PLANNING REPORT FOR A SECTION 146B REQUEST

In respect of lands at
**Peamount Road, Milltown and
Clutterland, Co. Dublin**

Prepared on behalf of
Data & Power Hub Services Ltd

Client:	Echelon Data Centres
Project Title:	DUB40 Campus Peamount Road
JSA Reference:	26067
Document Title:	Planning Report for a Section 146B Request

Figure 3.3: Permitted Substation & Grid Route ABP Reg. Ref. 309773-21

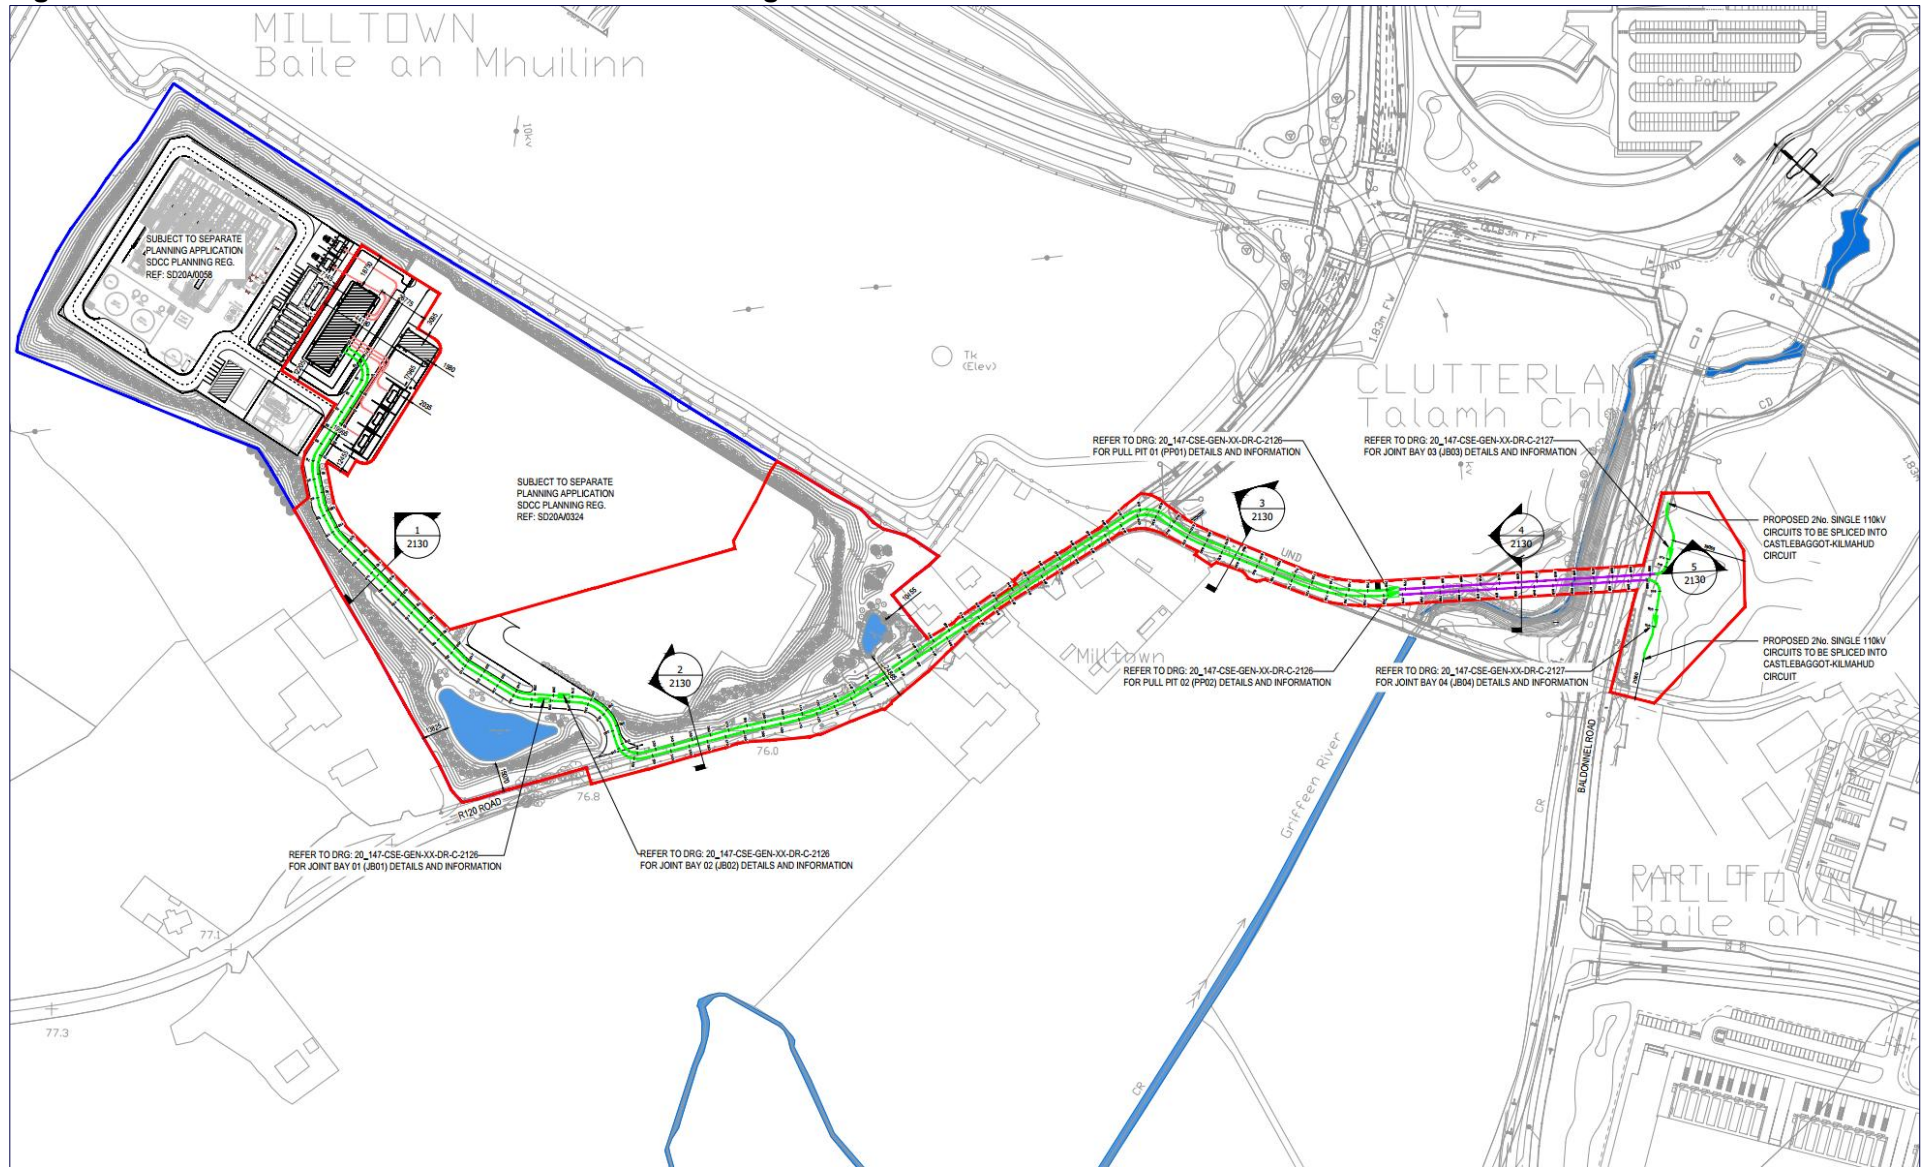
The alignment of both Circuit 01 Left and Circuit 02 Right remains generally the same as in the permitted development, with the greatest deviation from the permitted route proposed on the eastern side of the Baldonnell Road where both transmission lines extend slightly further east before making a 180° 'U-turn' to join the Castlebaggot-Kilmahud circuit to the north and south respectively.

The realignment of the Horizontal Directional Drilling (HDD) crossing under the Griffeen River and Baldonnell Road results in a slightly increase in the overall length of the proposed circuit, however the proposed changes decrease the total length of the HDD. The proposed changes to the HDD crossing do not alter the permitted associated mitigation measures and ensures potential impacts, as previously identified, are appropriately managed and mitigated.

Figure 6: Overall Layout Plan of Proposed Alterations

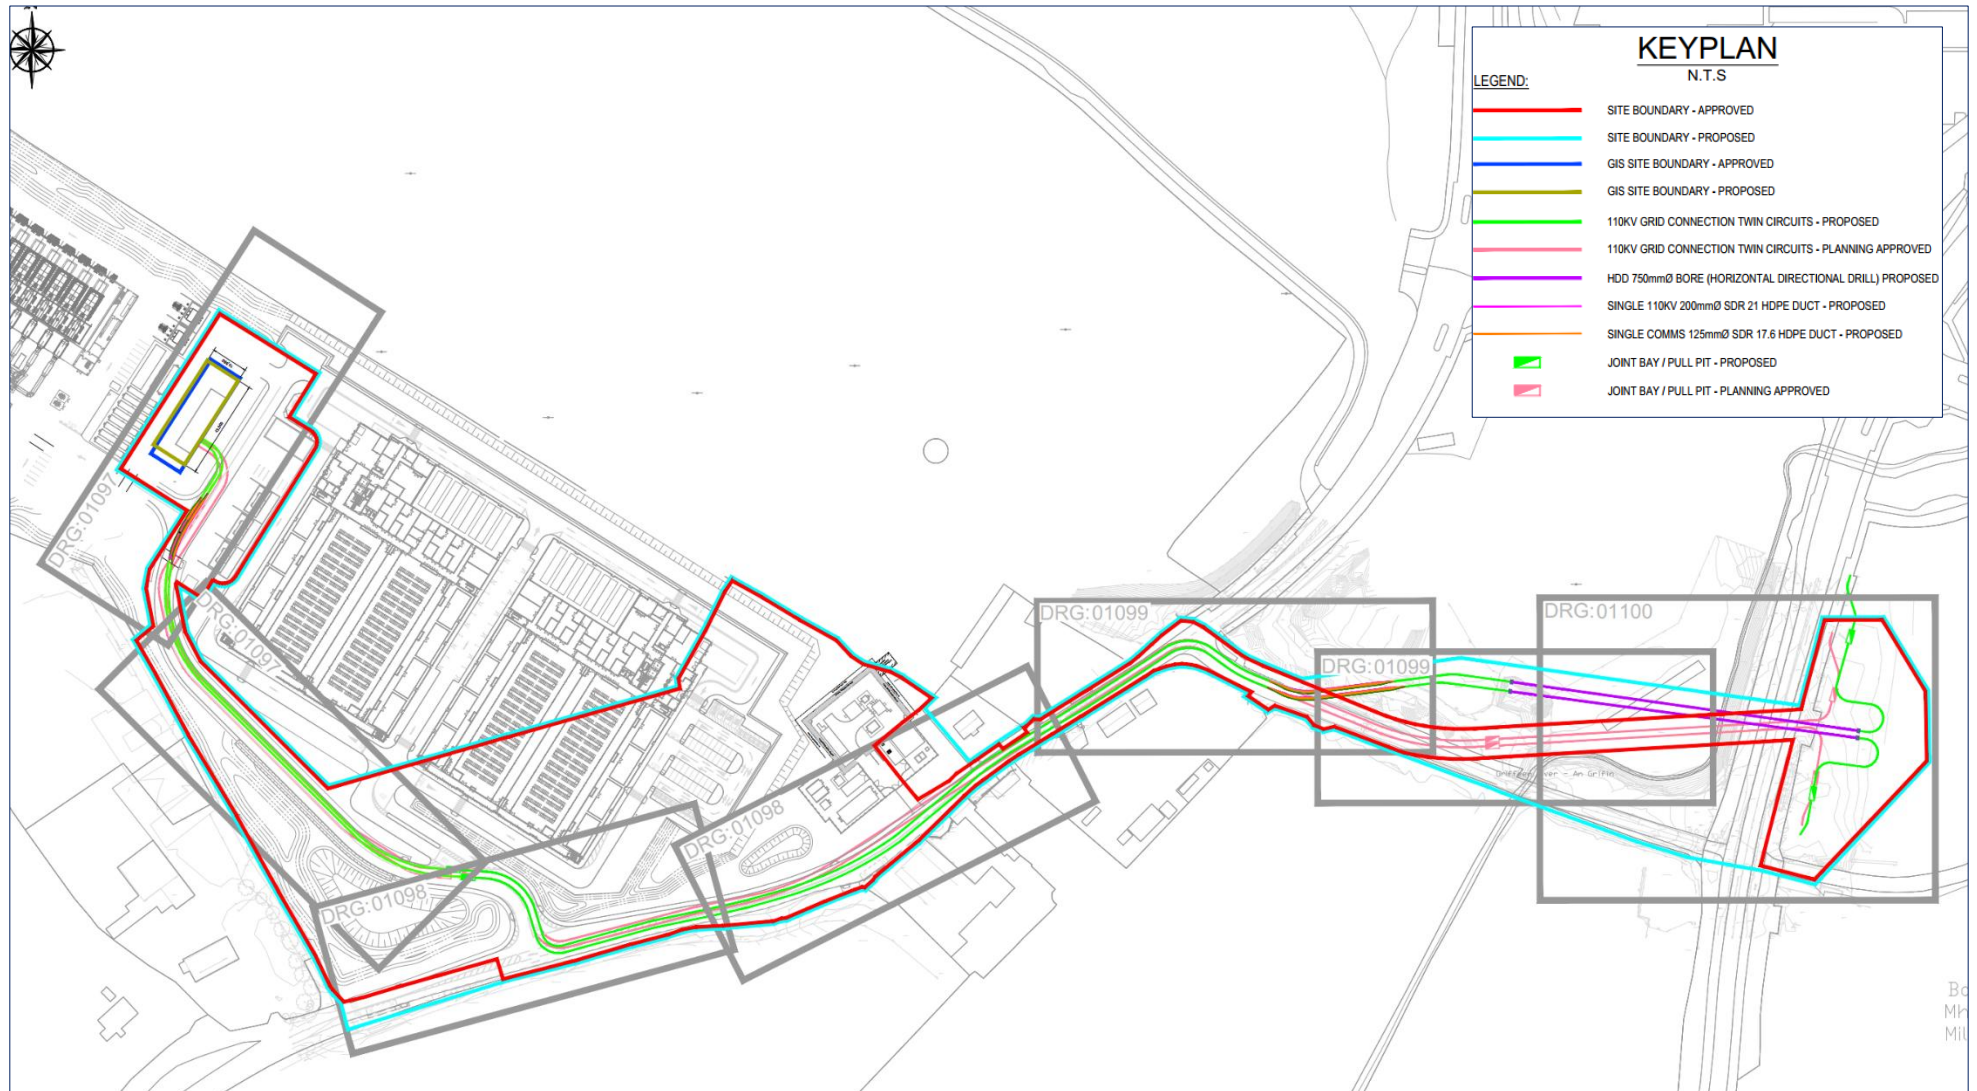
The proposed alterations to the Strategic Infrastructure Development, which this Section 146B relates to, can be summarised as minor amendments to the permitted alignment of the two 110kV underground transmission lines, referred to as Circuit 01 Left and Circuit 02 Right, to coordinate the lines with existing and proposed services. Details of the proposed alterations are set out in further detail below.

In the proposed alterations, Circuit 01 Left largely follows the permitted alignment from the permitted GIS substation traversing south-east along the route of the internal access road of the wider site permitted under SDCC Reg. Ref. SD20A/0058, before continuing north-east along the R120 (Peamount Road) for approximately 300m, then continuing south-east along the Old Nangor Road, with minor amendments to the alignment to avoid existing and proposed services along the internal access road and the R120 (Peamount Road). The proposed route alignment then veers north of the permitted route alignment and crosses under the Griffeen River and Baldonnell Road via horizontal directional drill (HDD) before performing a 180° ‘U-bend’ to connect to the existing Castlebaggot-Kilmahud circuit in the permitted location.

The proposed alterations to Circuit 02 Right largely mirror the proposed alterations Circuit 01 Left, with minor amendments to the alignment along the internal access road of the wider site and the R120 (Peamount Road), before veering north of the permitted alignment through greenfield and crossing under the Griffeen River and Baldonnell Road via HDD before performing a 180° ‘U-bend’ to connect to the Castlebaggot-Kilmahud circuit in the permitted location.

Description	Permitted	Proposed
Circuit 01 Left length	946m	991m
Circuit 02 Right length	938m	977m
HDD Circuit 01 Left Crossing length	168m	143m
HDD Circuit 02 Right Crossing length	168m	143m
Joint Bays Circuit 01 Left	3 no. joint bays	3 no. joint bays
Joint Bays Circuit 02 Right	3 no. joint bays	3 no. joint bays

- A change in the overall footprint from c.48.1m x c.14.88m to c.43m x c.15.88m;
- Building height increase from c.14.94 m to c.16.7m;
- A change to the building façade to have a monotone colour for the building in line with the material palette of the wider campus;
- Addition of external stairs from the first floor for fire escape and Part B compliance
- Minor adjustments to doors, vents and general finish of the building
- Updates to the internal layout of the GIS substation building;
- Adjustment of the palisade fence and boundary treatments;
- General updates to ducting, lighting, interface kiosks and rural supply
